Smart motorways

Incident and infrastructure investigation

M1 Junction 39 to 42

Highways England response

Figure 1 Public rights of way parallel to and across the motorway between J39 and J40
© Google

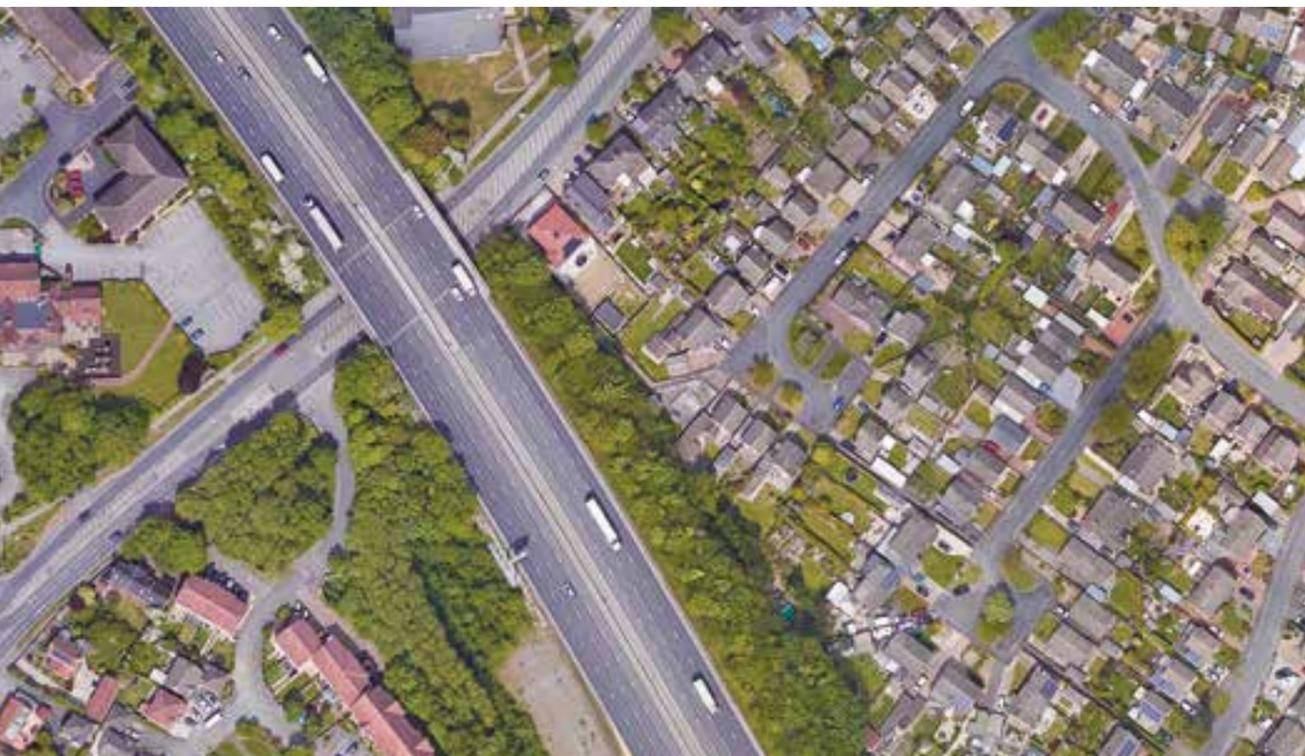
Pedestrian incident reports are most common on the J39 to J40 link, which runs between two suburban areas. The range of potential crossing and access points, and the suburban setting of this link are risk factors and although they appear to serve most pedestrian routes, the provision and fencing details vary.

- The J39 to J40 link is the link closest to built up areas of Lupset to the east and South Ossett to the west.
- An extensive network of recreational footways running parallel to the M1 just north of junction 39 provides potential access to the motorway.
- Potential access for pedestrians from public footways at Queens Drive and Northfield Lane (A642).
- Junction 40 links residential areas with employment areas in Ossett and towards Wakefield and so could be used by pedestrians.

Review the access points along the route and install anti-access fencing at specific locations on the J39 to 40 link, to prevent access to the motorway for pedestrians and remove the risk of further incidents.

Consider higher parapets on the overbridges at J40, with Samaritans crisis signs and an emergency telephone for customers in crisis in line with the suicide prevention toolkit. A site assessment has identified these as potential measures to be developed through further feasibility work.

We have reviewed the study area to identify potential pedestrian routes and areas where the M1 can be accessed by those on foot. A desire on the part of pedestrians to access or cross the motorway represents a clear hazard to all road users. The measures identified remove this hazard.

Intervention 1 and 2 will both be progressed. Intervention 2 will require detailed feasibility work in the first instance to identify the most suitable options to develop through detailed design and delivery.
